PLANS AND DOCUMENTS referred to in the PDA DEVELOPMENT APPROVAL

Approval no: DEV2020/1150/2

AMENDED IN RED

FLIPSIDE CIRCUS NORTHSHORE

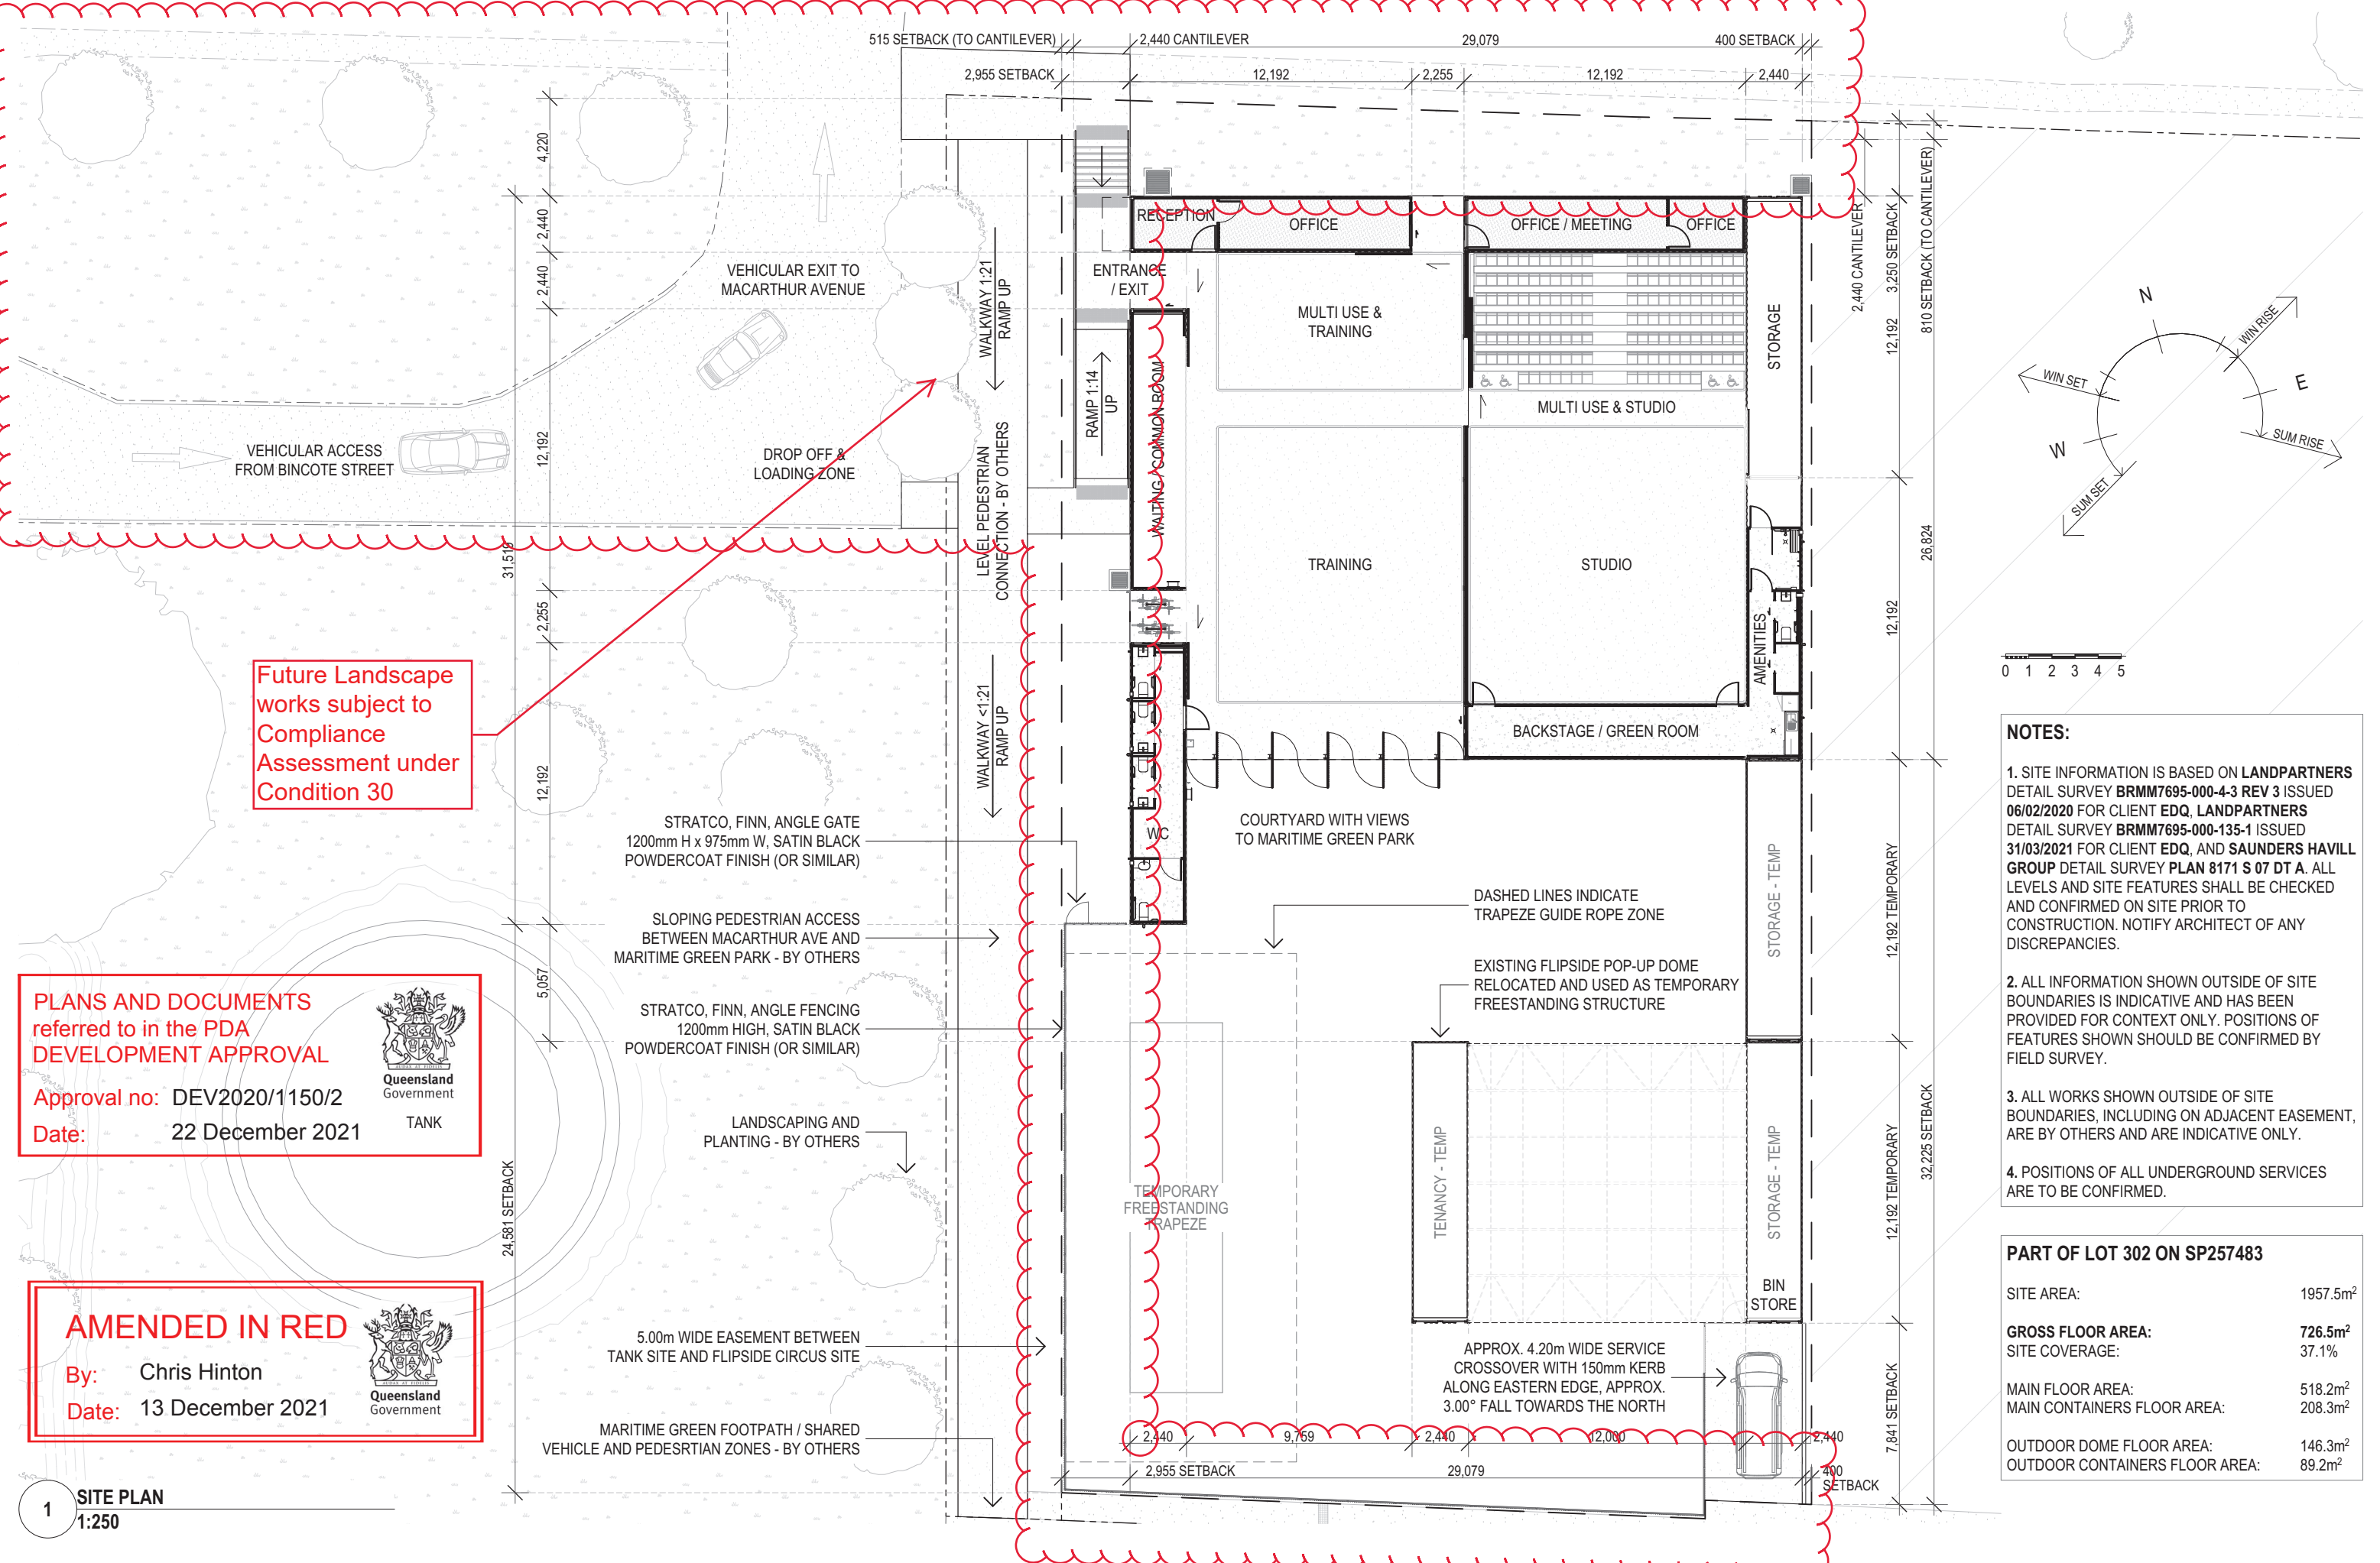
Future Landscape works subject to Compliance Assessment under Condition 30

1 OVERHEAD POWER LINES PLAN
1:150

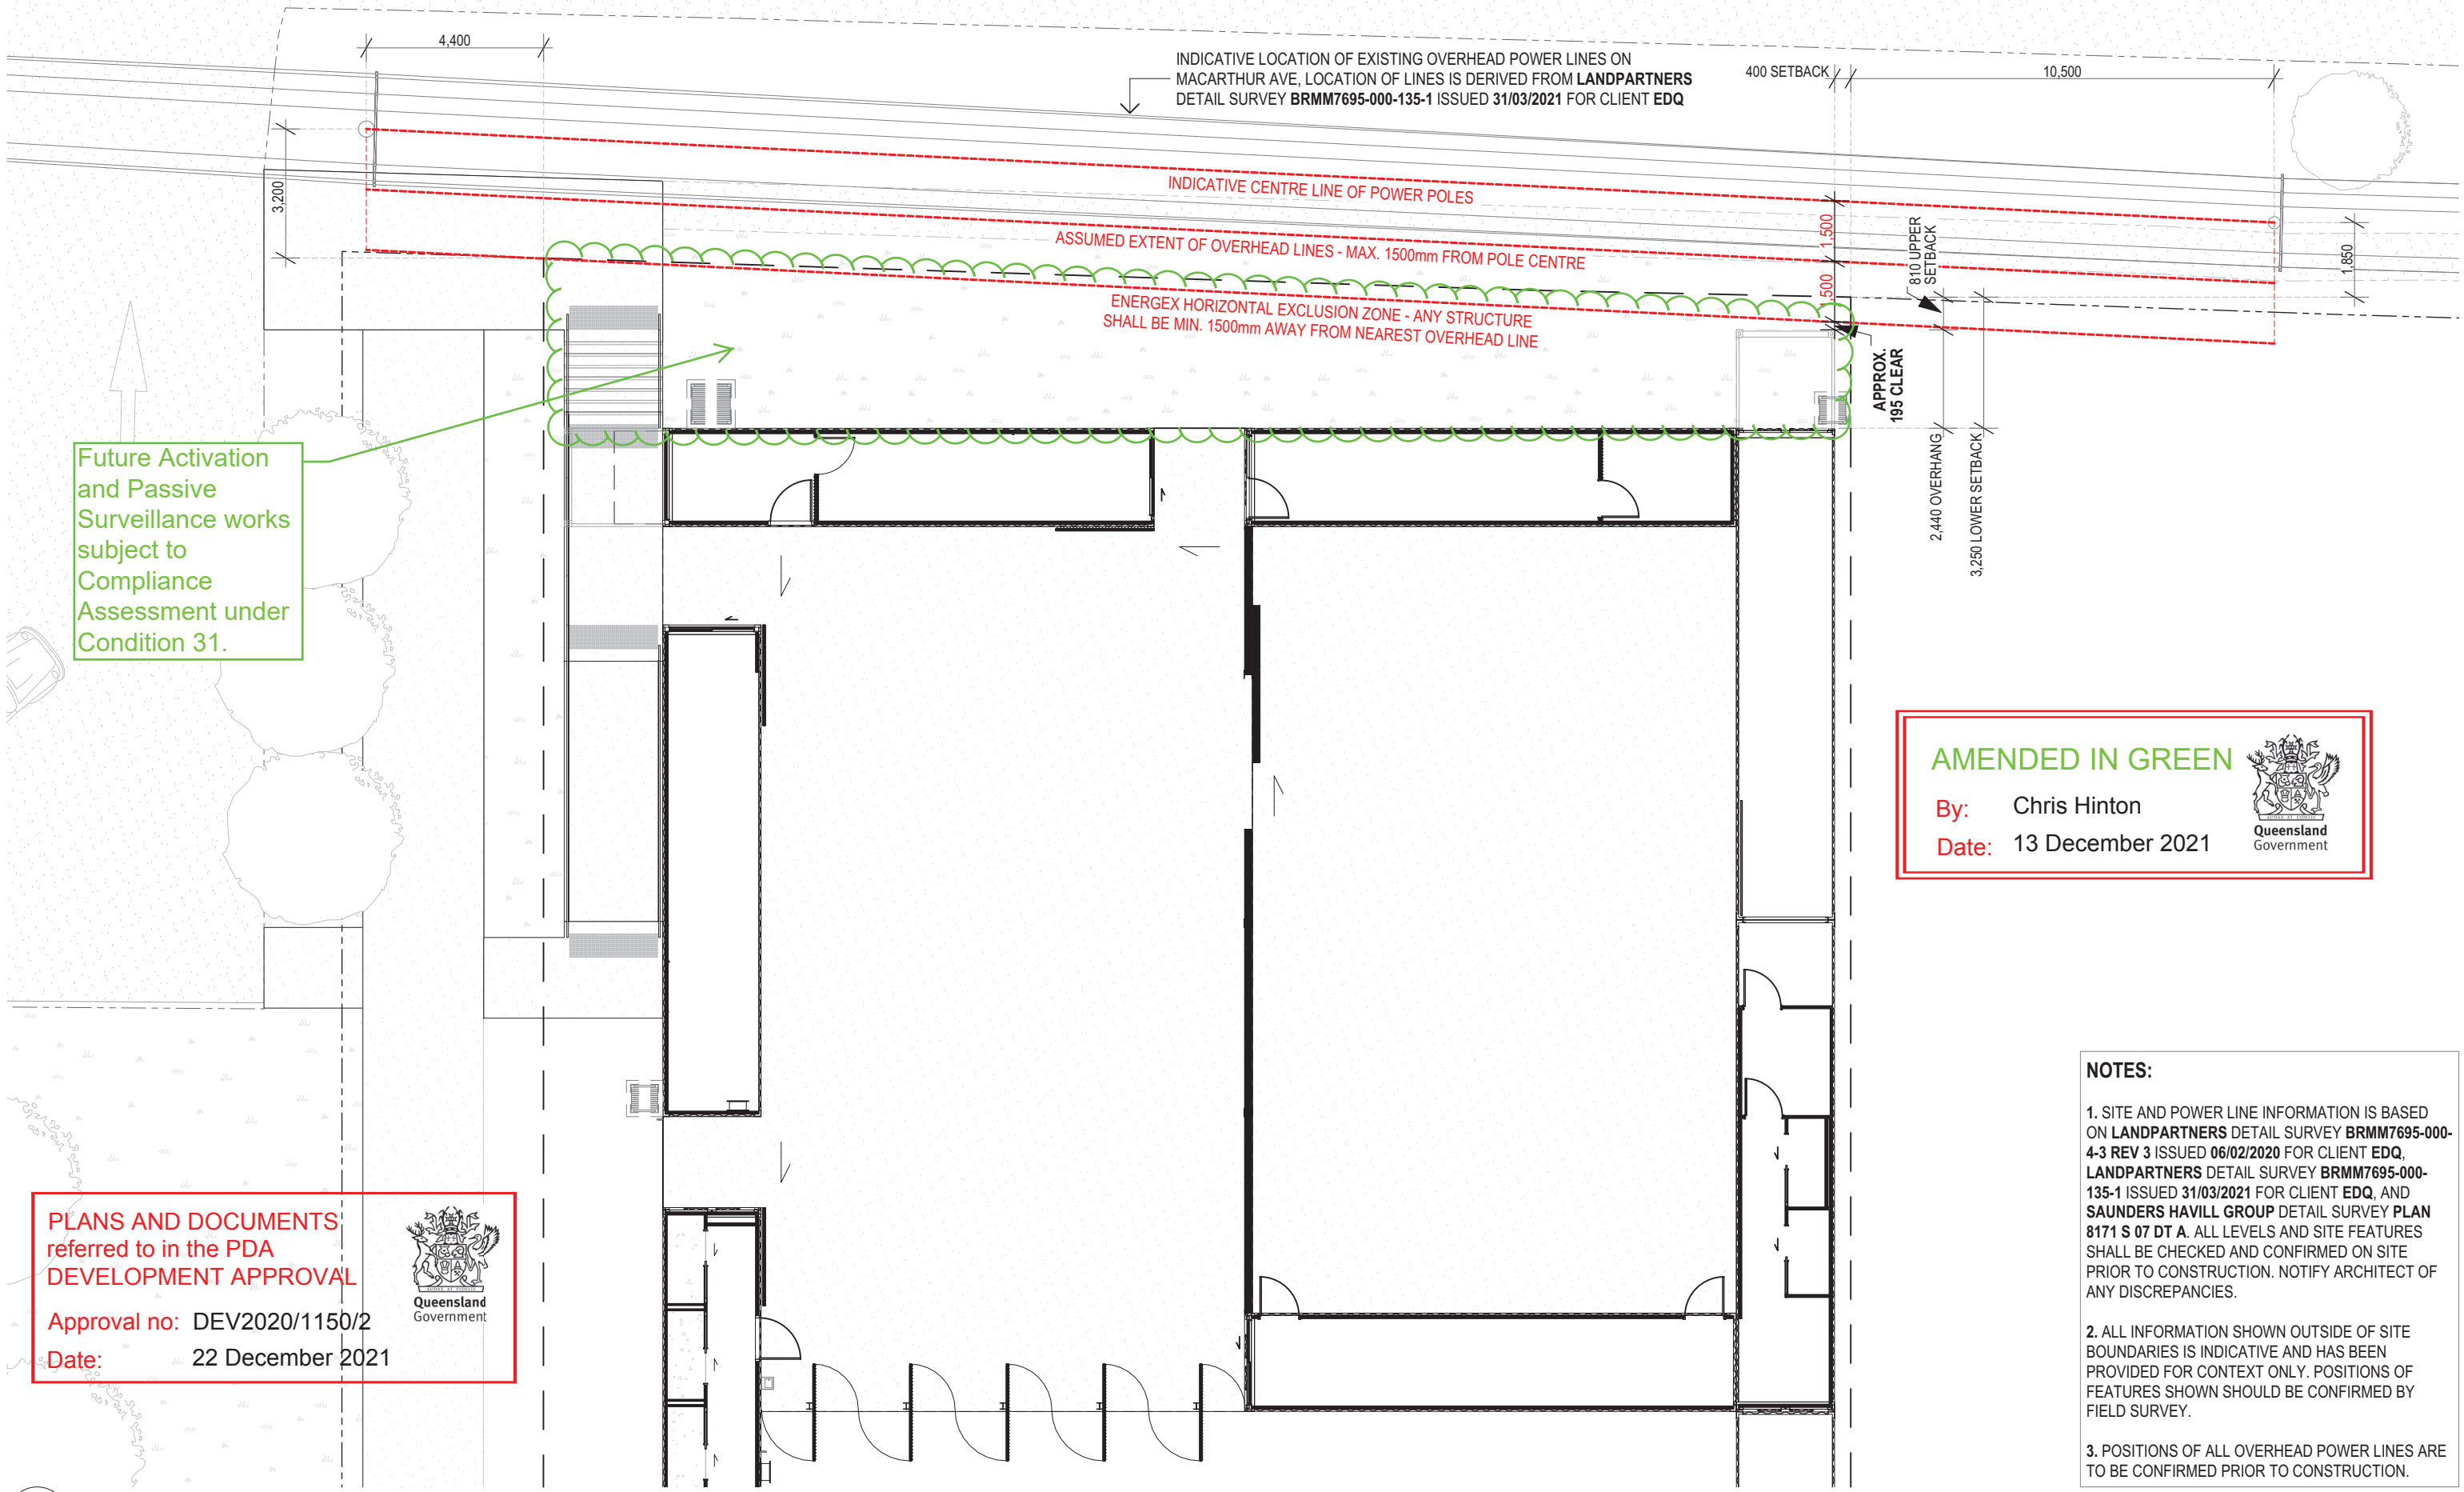
Window to be fully transparent and free from obstructions (E.g. the bars currently shown)

Window to be fully transparent and free from obstructions (E.g. the bars currently shown)

GROUND FLOOR PLAN
1:150

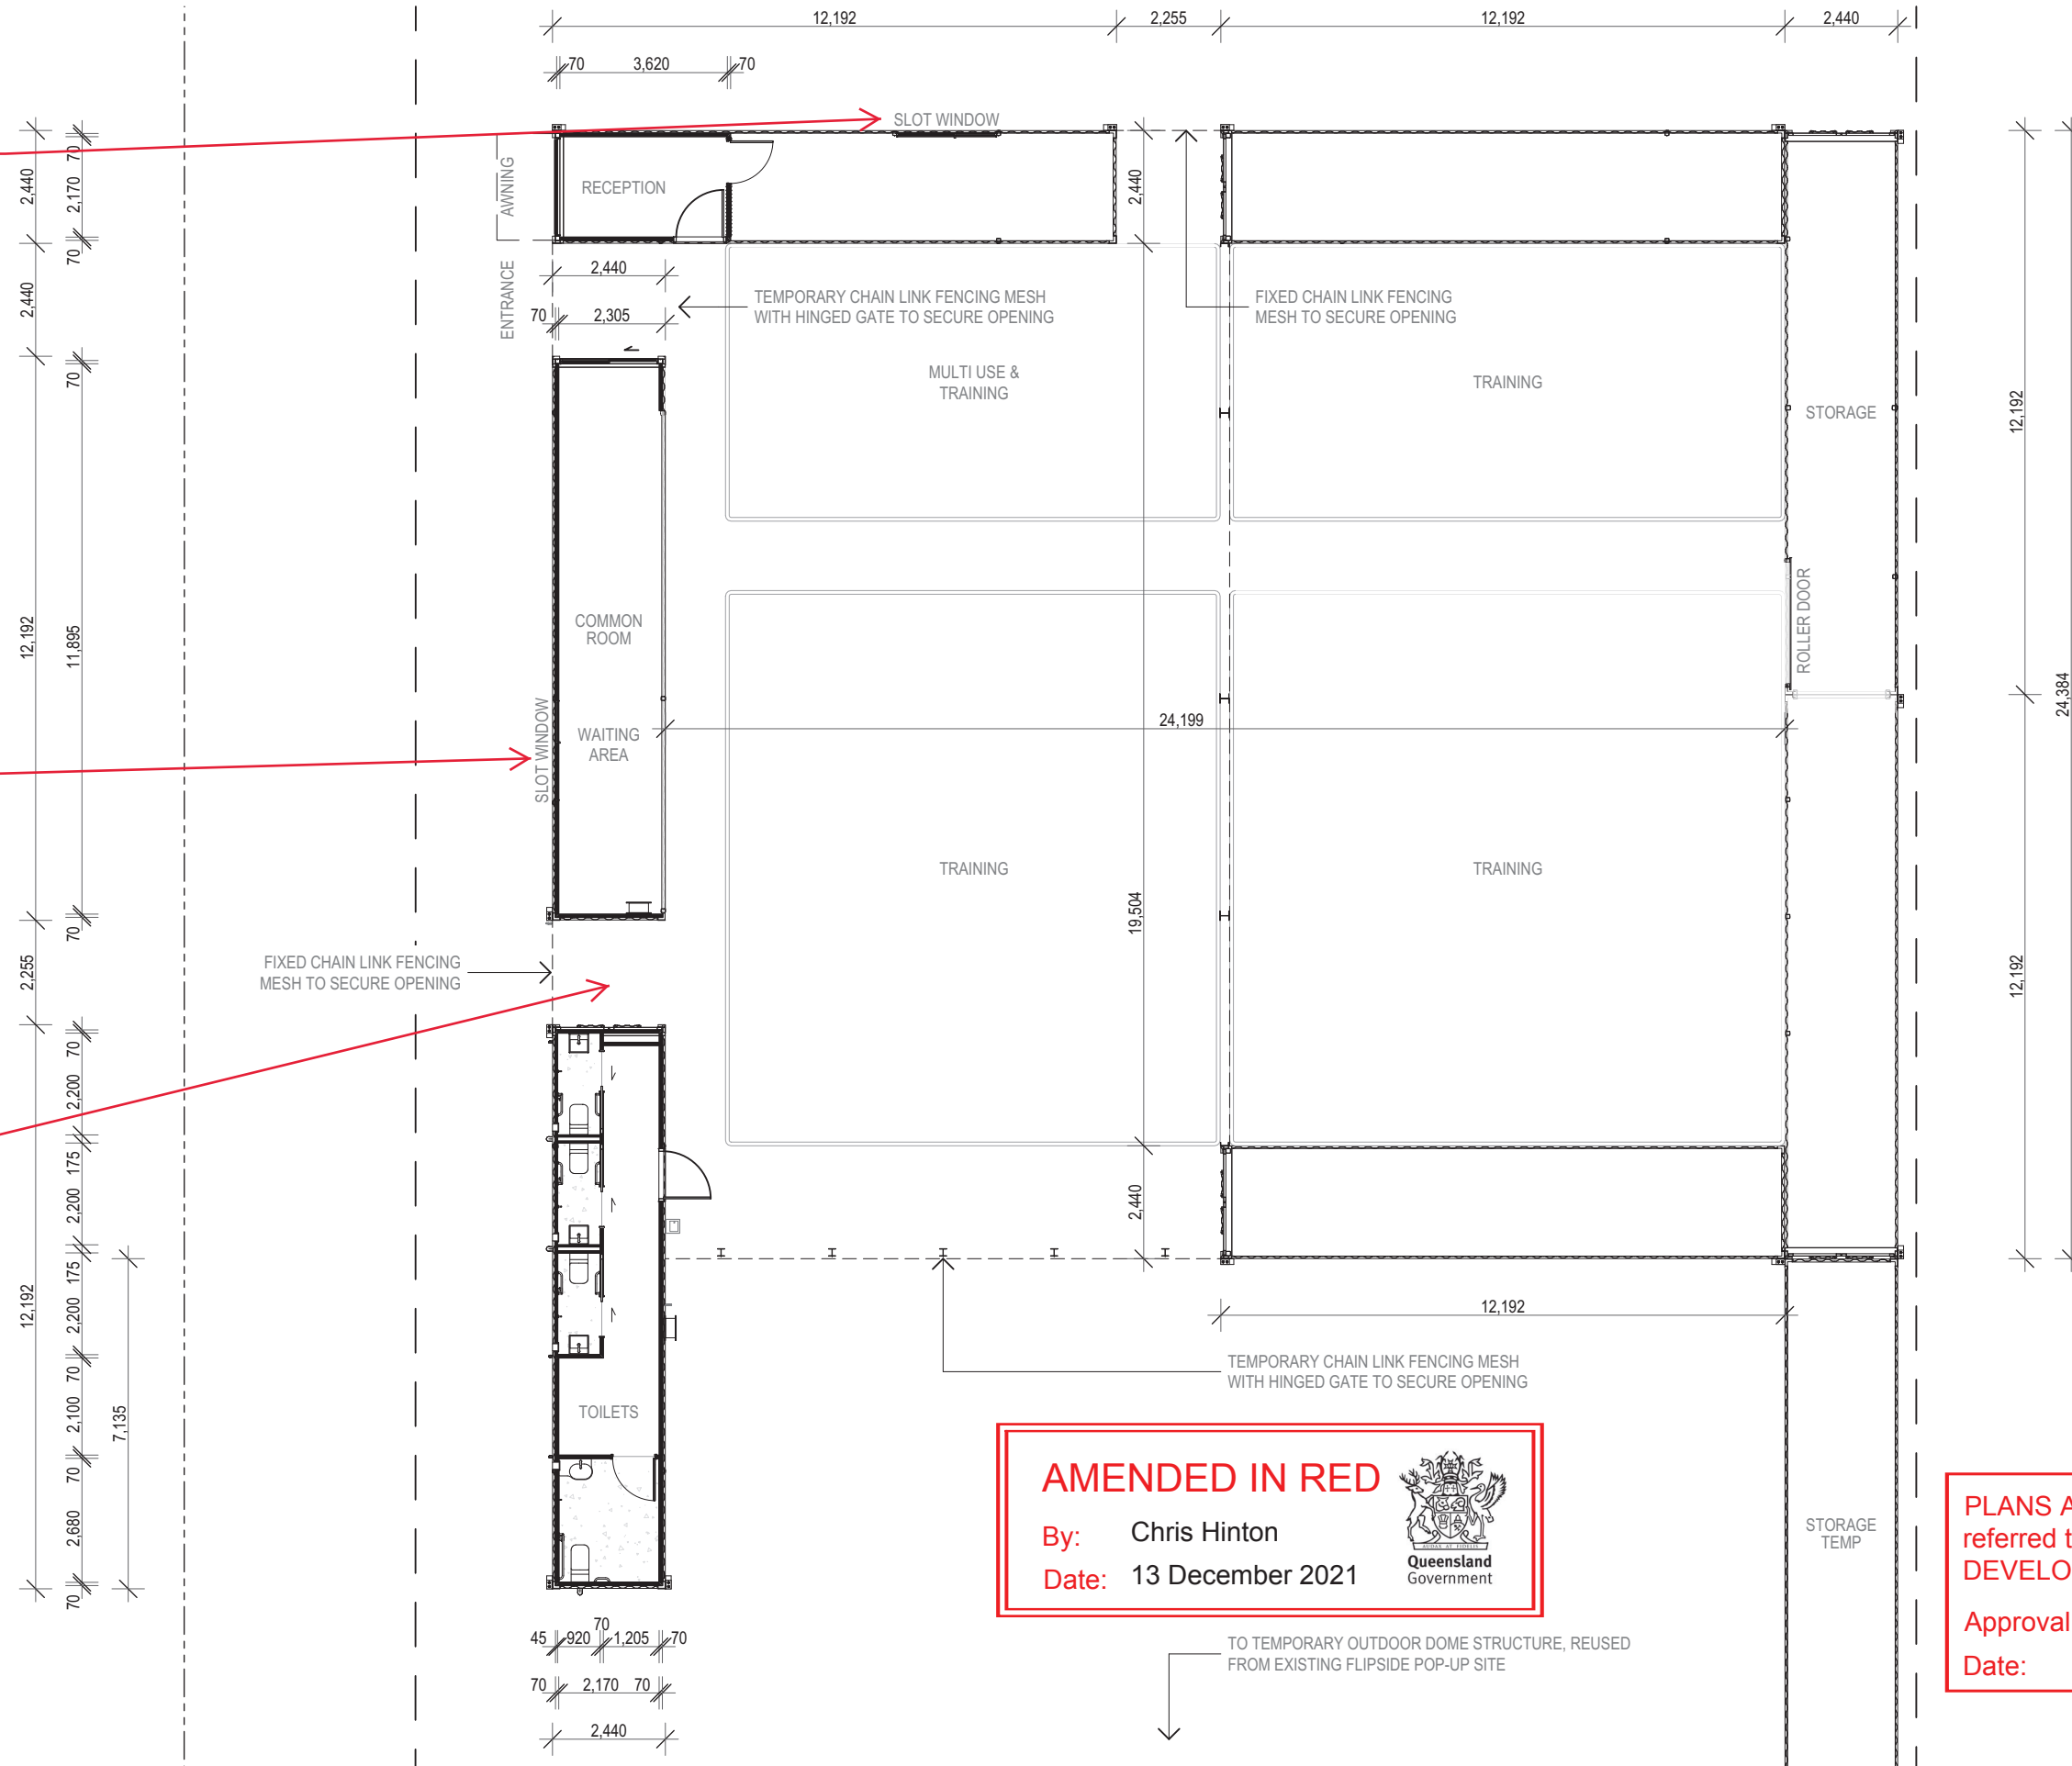
Bicycle parking to be provided in Stage 1 in accordance with approved plan 'End of Trip Plan - Stage 2' prepared by Blok (Drawing 2003, Issue DD16, dated 1 December 2021 (Amended in Red 13 December 2021))

TO TEMPORARY OUTDOOR DOME STRUCTURE, REUSED FROM EXISTING FLIPSIDE POP-UP SITE
